June 10, 2021

RE: Proposed Alterations at 65 Hillside Avenue (Tax ID 4.80-62-20)

Please find attached revised drawings showing the following minor changes and clarifications that had been requested during our previous May meeting:

65 HILLSIDE AVE HOH, NY 10706

FLOOR PLAN AND NOTES

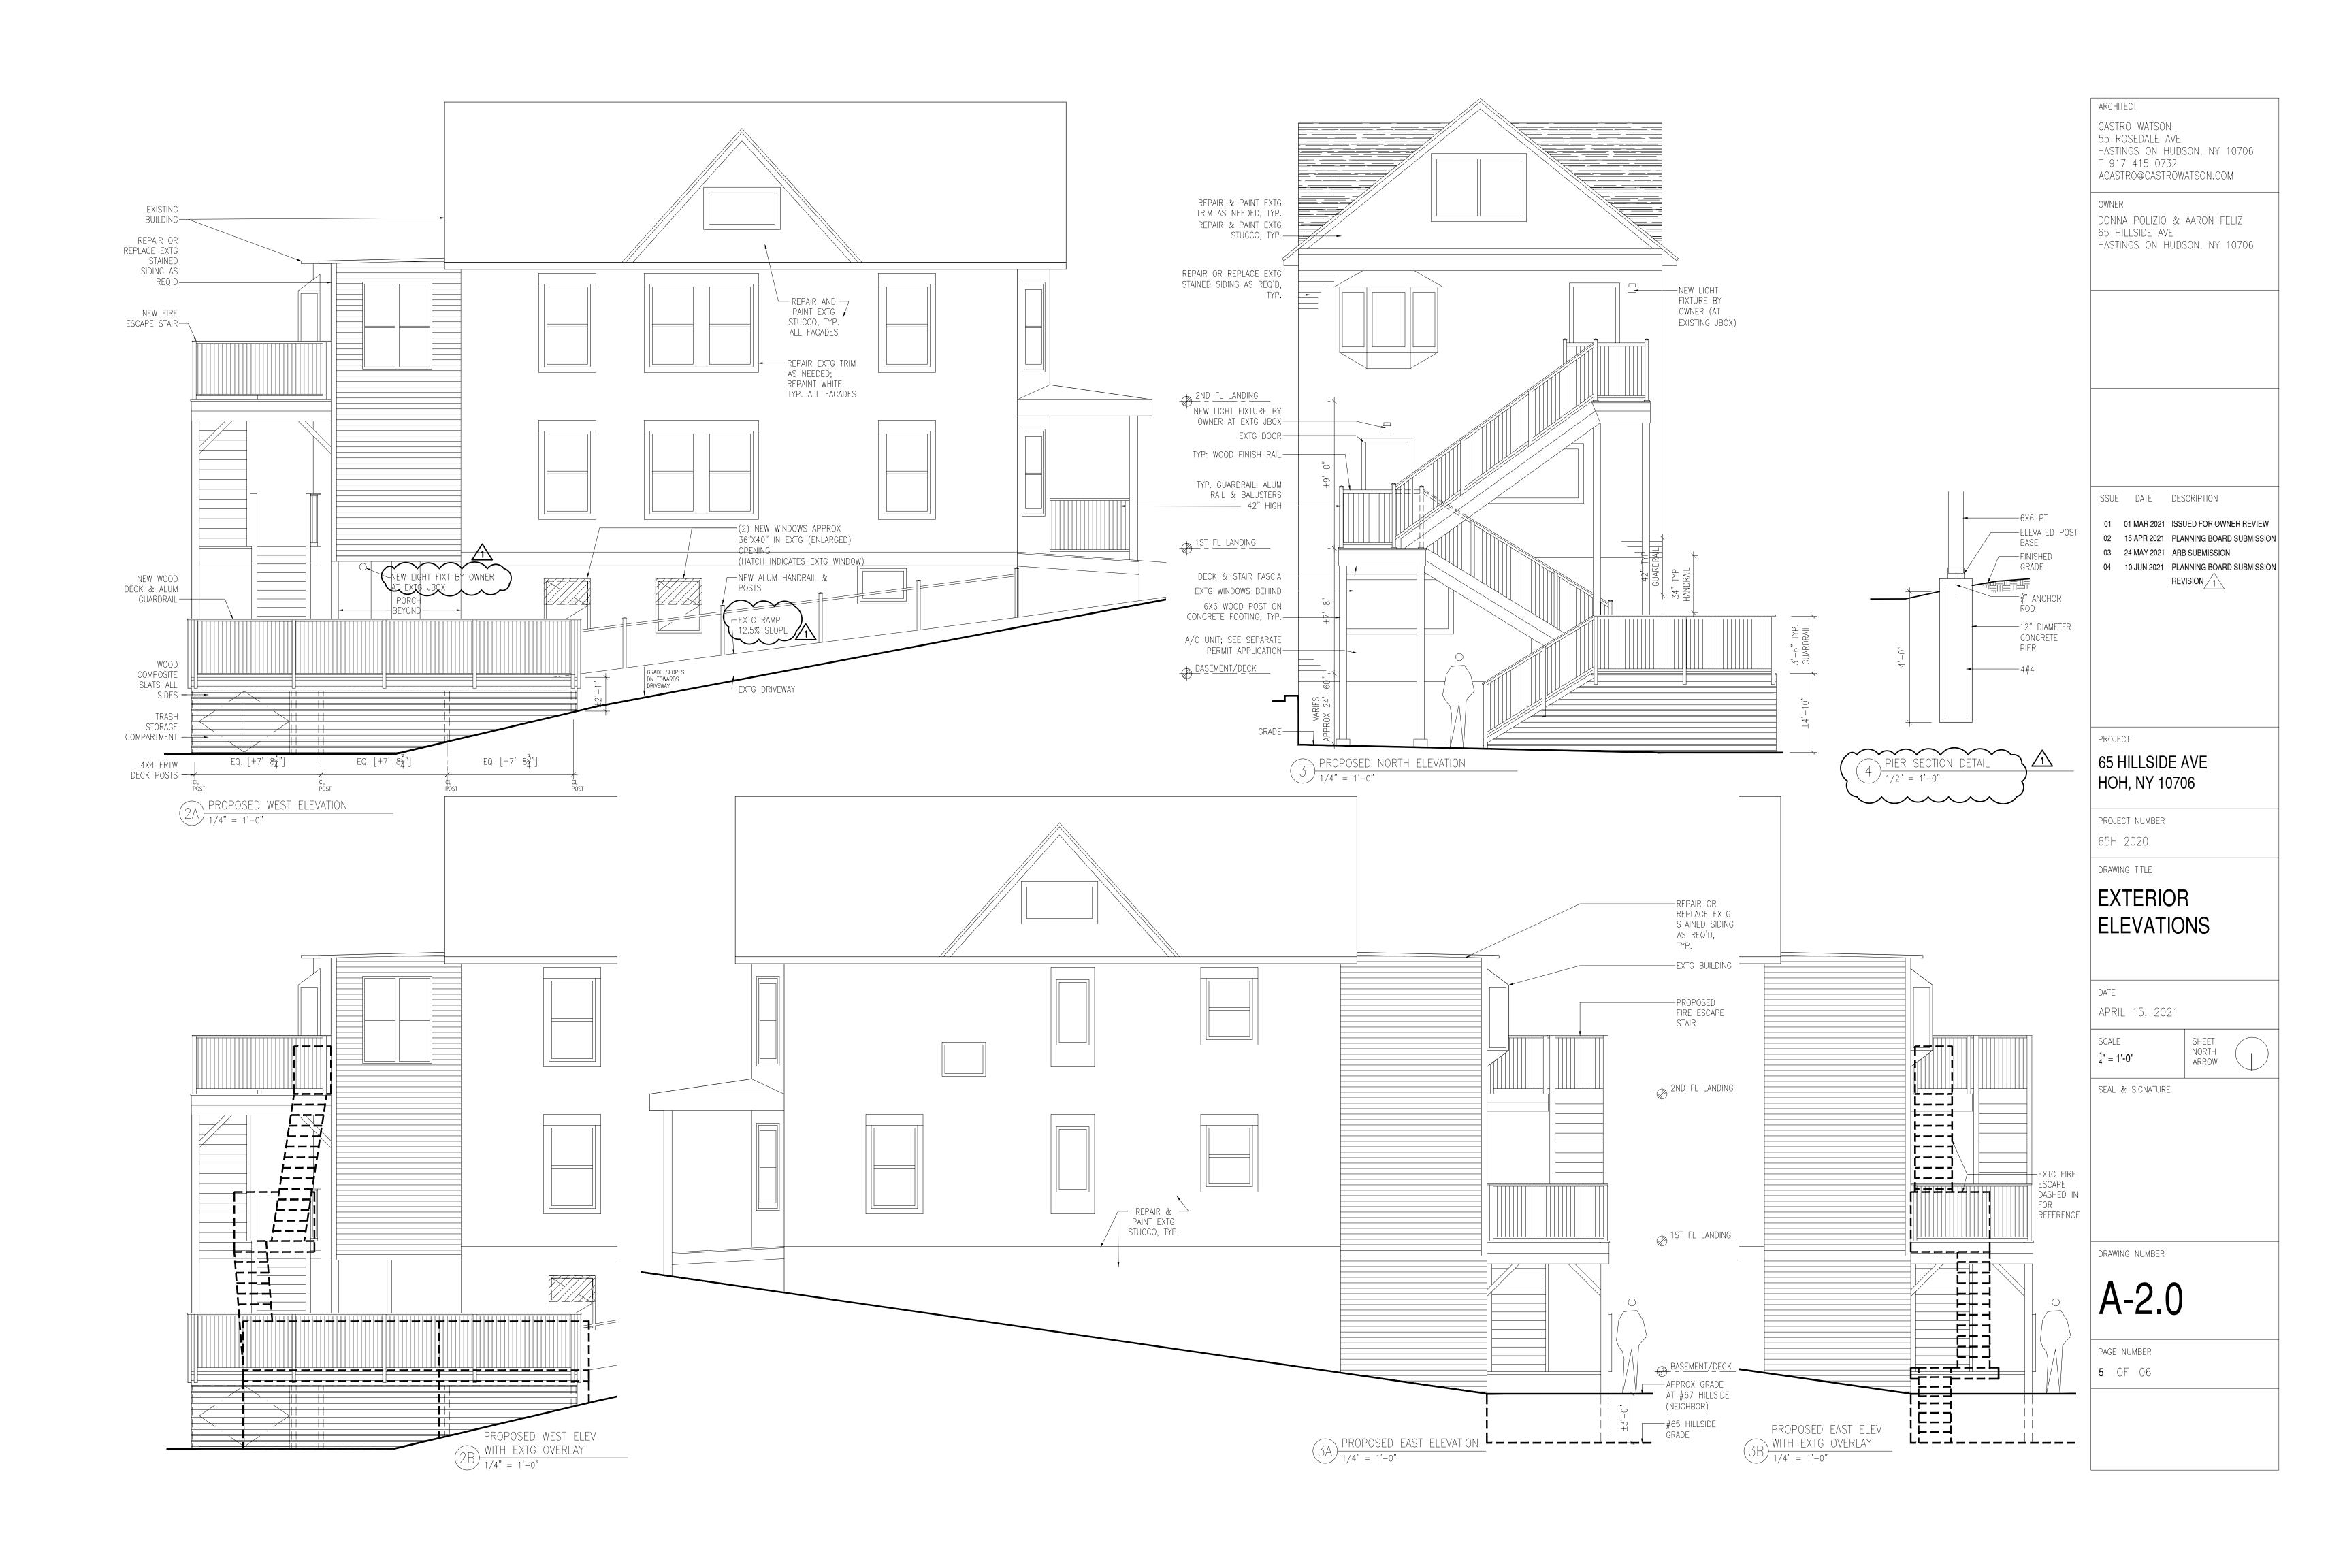
- 1. Foundation pier detail for the deck and rear second means of egress.
- 2. Pervious paving detail.
- 3. In lieu of a trench drain and to address the ponding of water at the end of the driveway, we are proposing to replace the entire existing concrete slab with pervious paving.

- FIRE ESCAPE SHALL BE CONSTRUCTED TO SUPPORT
- A LIVE LOAD OF 100 PSF AND NO LESS THAN NOMINAL 2 INCHES THICK FOR WOOD SUPPORTS. BOTTOM OF POST CONCRETE FOOTINGS TO BE 12" BELOW FROST LINE AND SHALL REST ON UNDISTURBED SOIL WITH A BEARING CAPACITY OF
- 4000 PSF. - P.T. LEDGER BOARDS BOLTED TO WALL STUDS; DETAILS TO FOLLOW. PROVIDE COPPER FLASHING ABOVE LEDGER TO EXISTING EXTERIOR SHEATHING. - ALL FASTENERS TO BE MIN. 18 GAUGE, STAINLESS STEEL OR HOT-DIPPED GALVANIZED, STEEL

- ASSEMBLIES, SUCH AS SIMPSON STRONG-TIE. INSTALL PER MANUF. RECOMMENDATIONS. - ALL WOOD TO BE PRESSURE-TREATED, TYP.
- DECK SUPPORTING FIRE ESCAPE SHALL BE CONSTRUCTED TO SUPPORT A LIVE LOAD OF 100 PSF AND NO LESS THAN NOMINAL 2 INCHES THICK

FOR WOOD SUPPORTS. - 4X4 P.T. WOOD POSTS ON CONCRETE FOOTINGS.
